**AGENDA
MAPLE PLAIN CITY COUNCIL – SPECIAL MEETING
MAPLE PLAIN CITY HALL
JULY 16, 2018
5:30 P.M.**

Request by Elim Care, Inc./Augustana Care for Site Plan Review, Preliminary Plat and Final Plat to Allow a Mult-Family Senior Housing Development on the Property Located at 1425 Baker Park Road

<i>To:</i>	City Council
<i>From:</i>	Mark Kaltsas, City Planner
<i>Meeting Date:</i>	July 16, 2018
<i>Applicant:</i>	Elim Care, Inc./Augustana Care
<i>Owner:</i>	Maple Plain Gateway Prop., LLC
<i>Location:</i>	1425 Baker Park Road

To:	Mark Kaltsas	From:	Dan D. Boyum
	City Planner		City Engineer
File:	193804259	Date:	July 10, 2018

PRELIMINARY REMOVALS PLAN

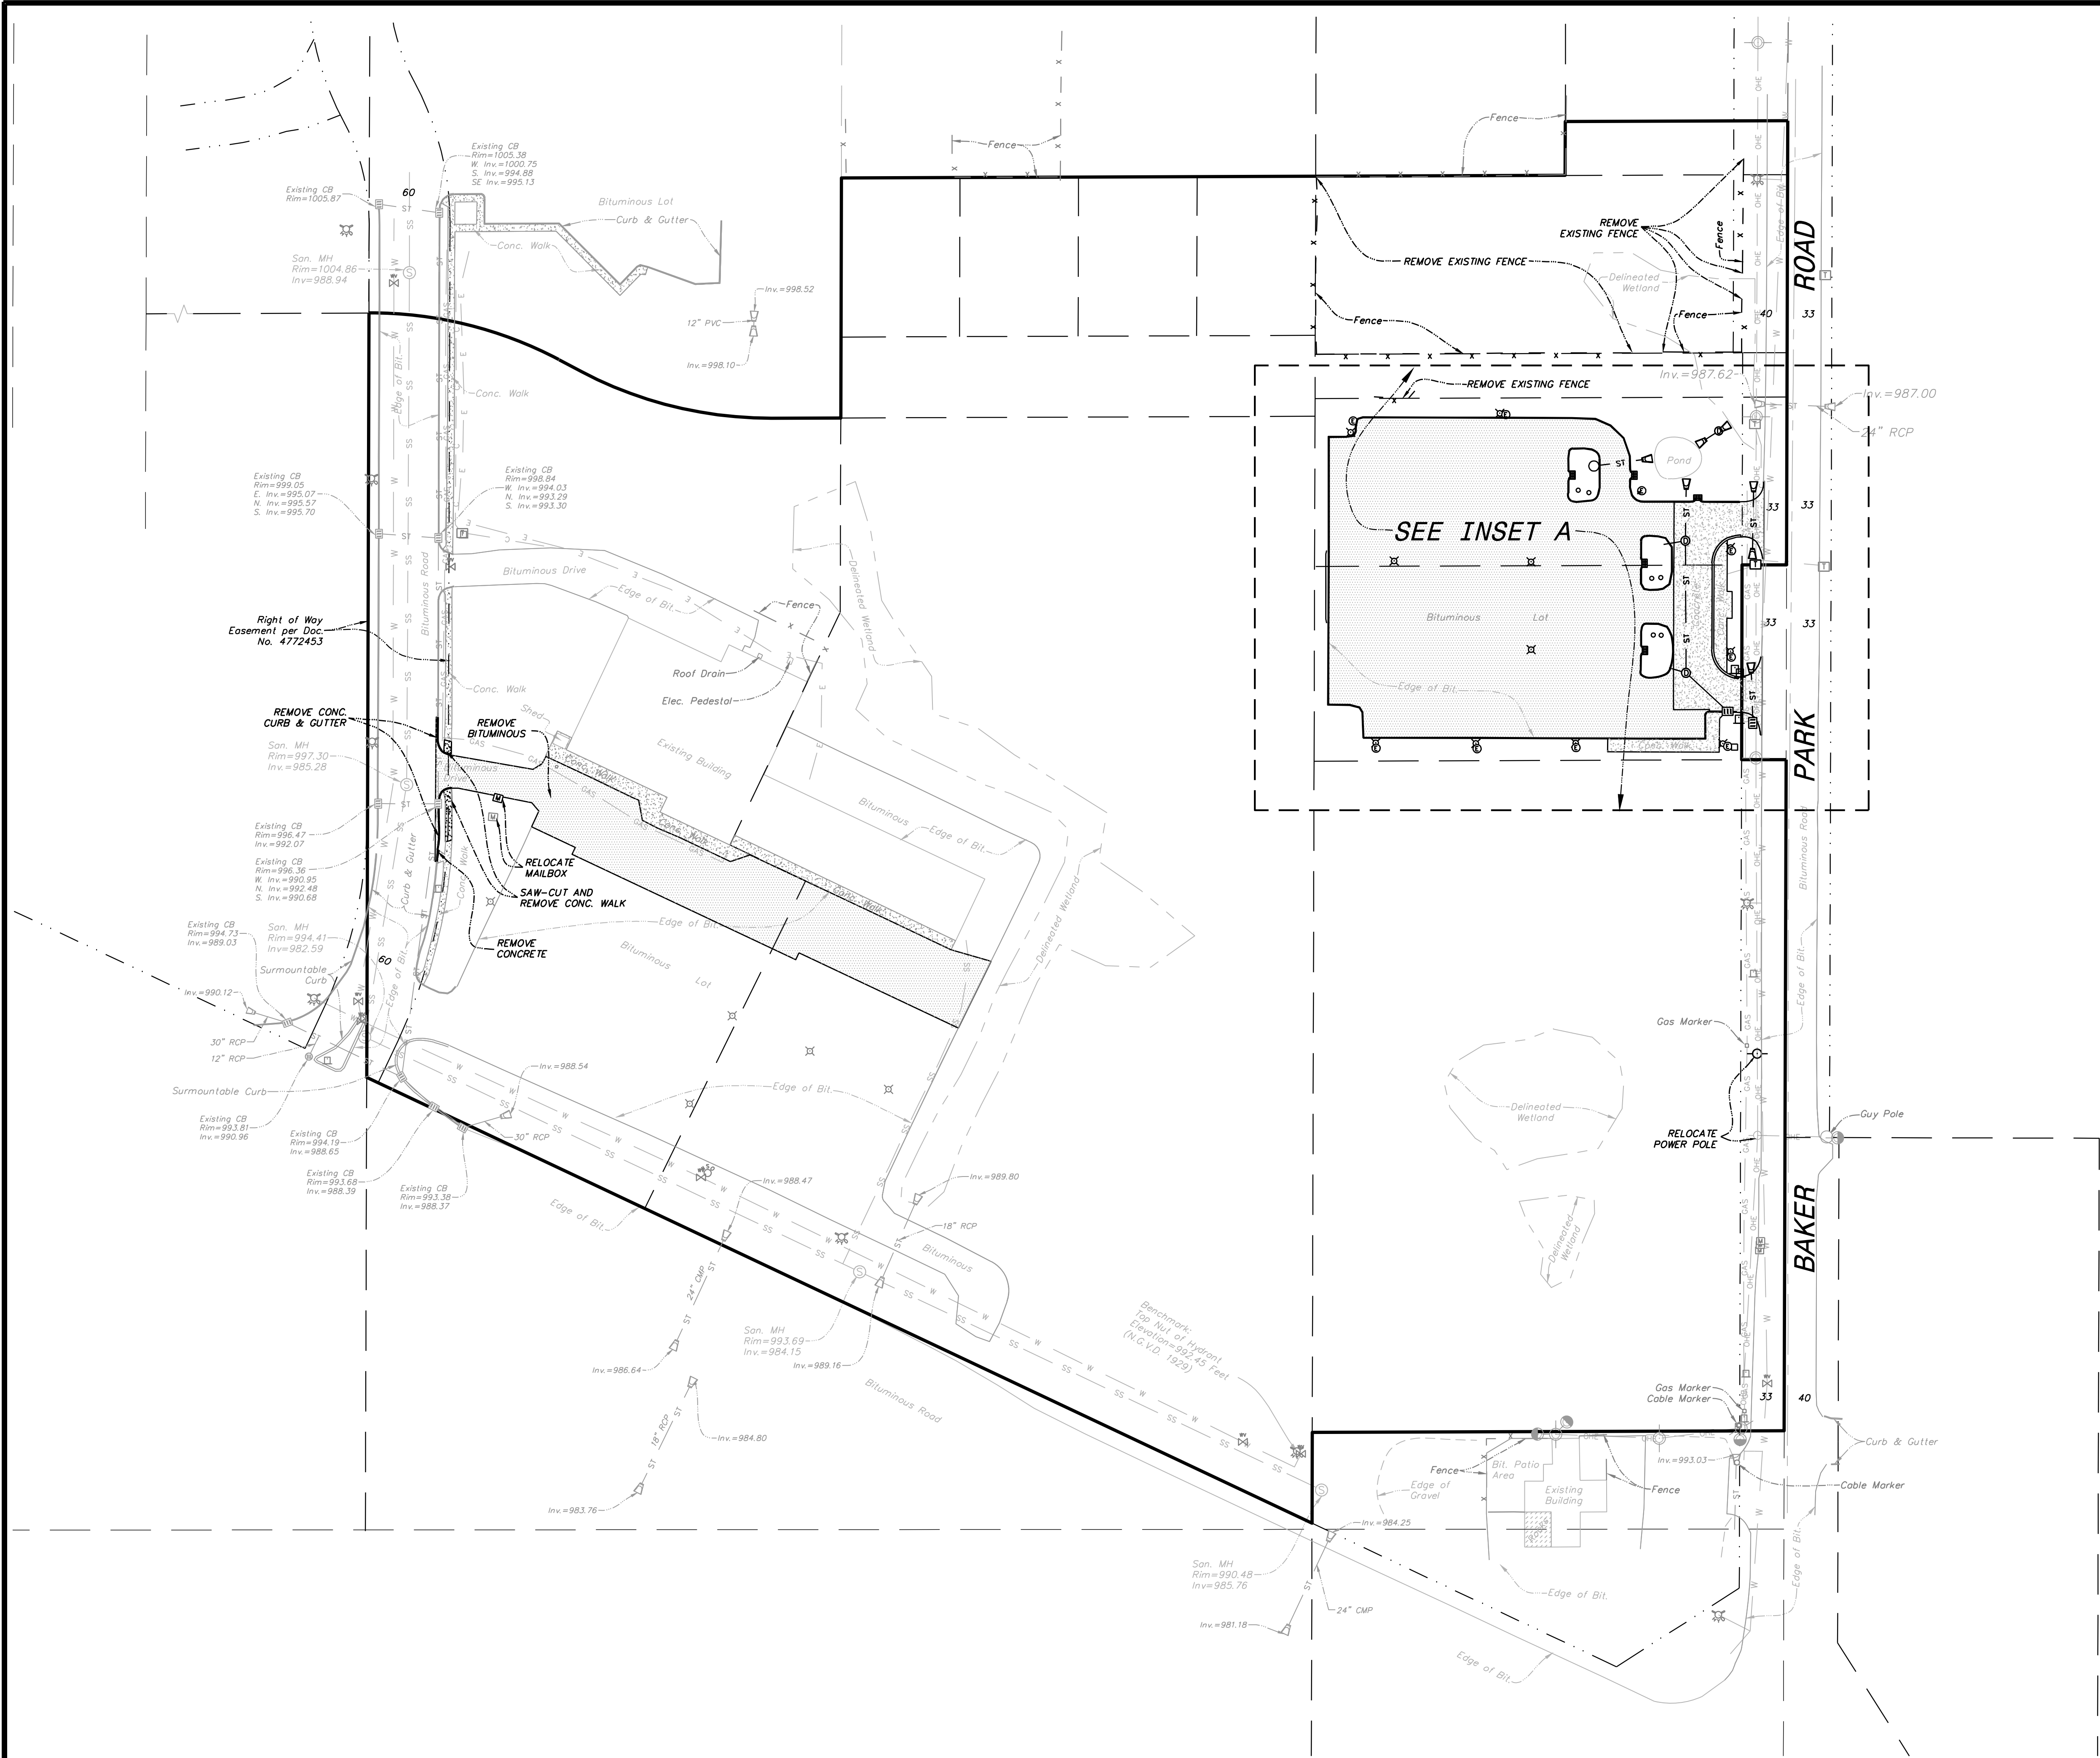
Preliminary Removals Plan (Sheet C2 and C3)

8. Not all removals are shown on this sheet. Some are shown on other sheets such as the utility drawings.

PRELIMINARY SITE PLAN	PROJECT NO. 17-0297
SHEET NO. C4 OF C13 SHEETS	DATE: 3-28-18

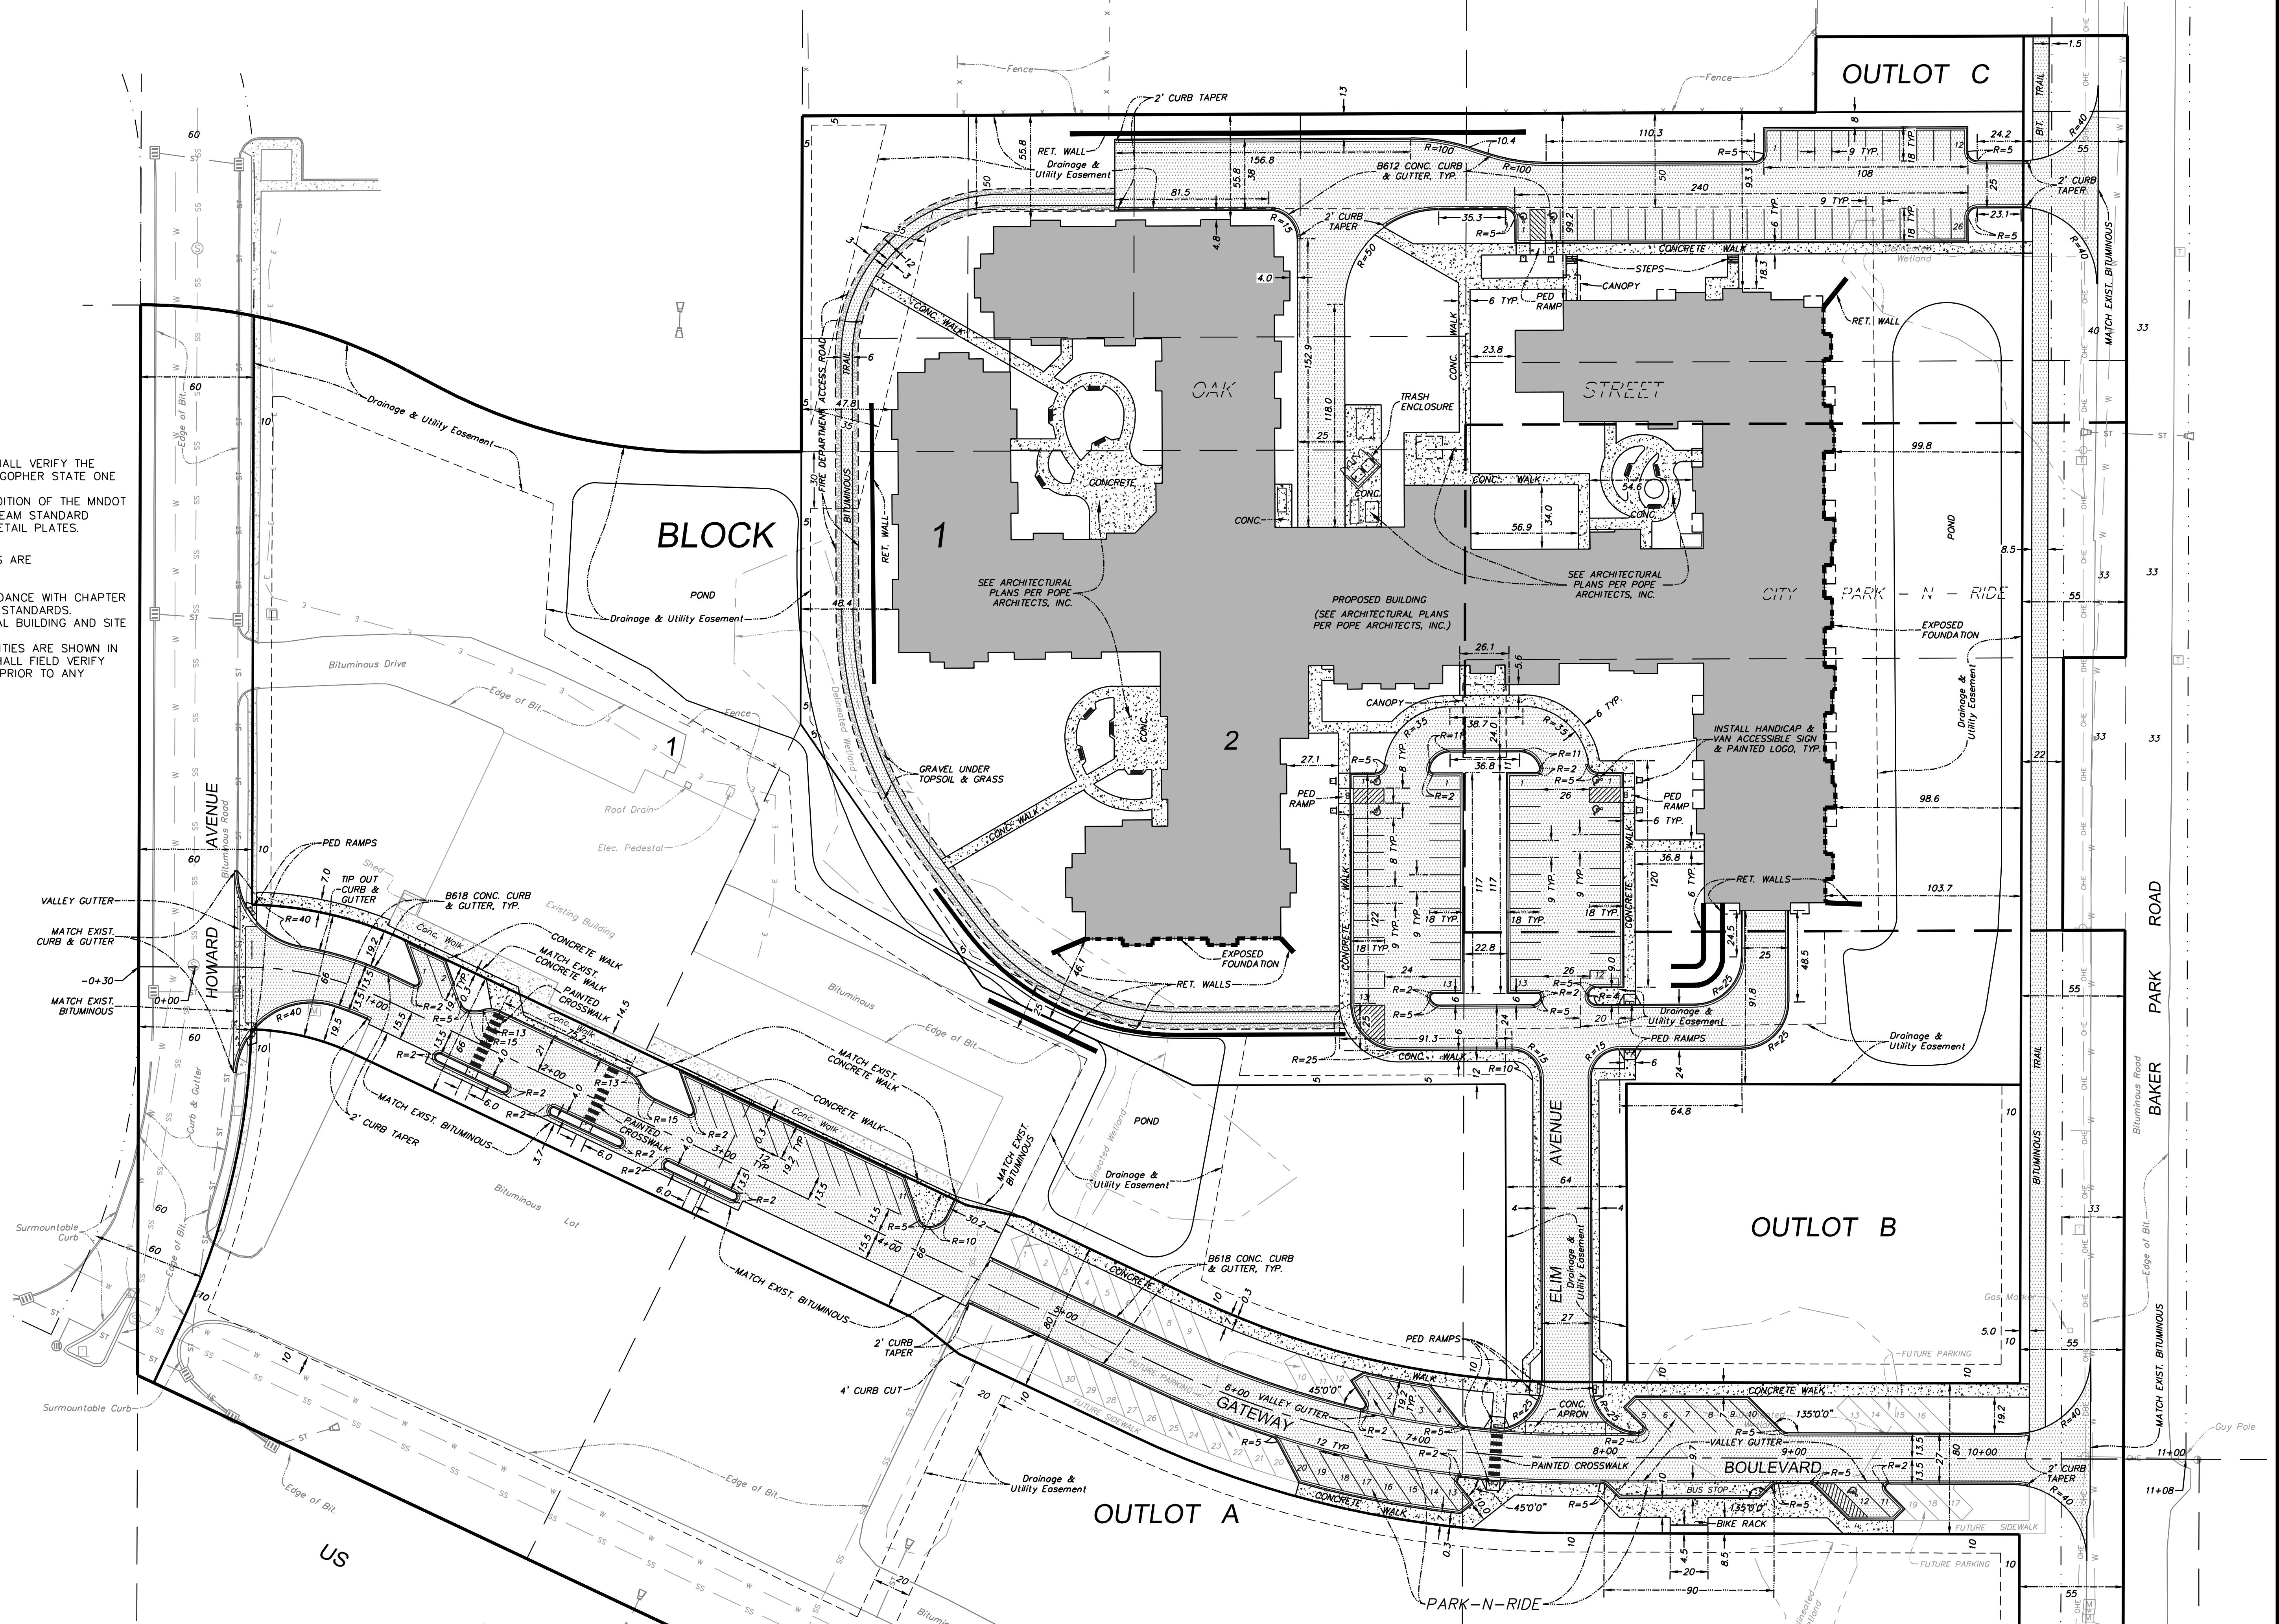
Preliminary Site Plan (Sheet C4)

9. Additional pedestrian ramps and/or depressed curbs should be added at the current or future trail/sidewalk crossings on the development. We can add any final comments on the final plans.
10. Existing Parking Lot between Block 1, Lot 1 and Outlot A.- No curb and gutter or storm sewer structures are shown for this area. Drainage is proposed to continue to the south as it currently does. Curb and gutter and storm sewer can be added with future development of Outlot A. See the City Planner's comments on additional islands to be placed, width of islands, and some additional curbing at the transition to the existing parking lot.
11. If a turn lane is needed in the future on Gateway Boulevard as it connects to Baker Park Road, some of the future parking areas may need to be relocated.
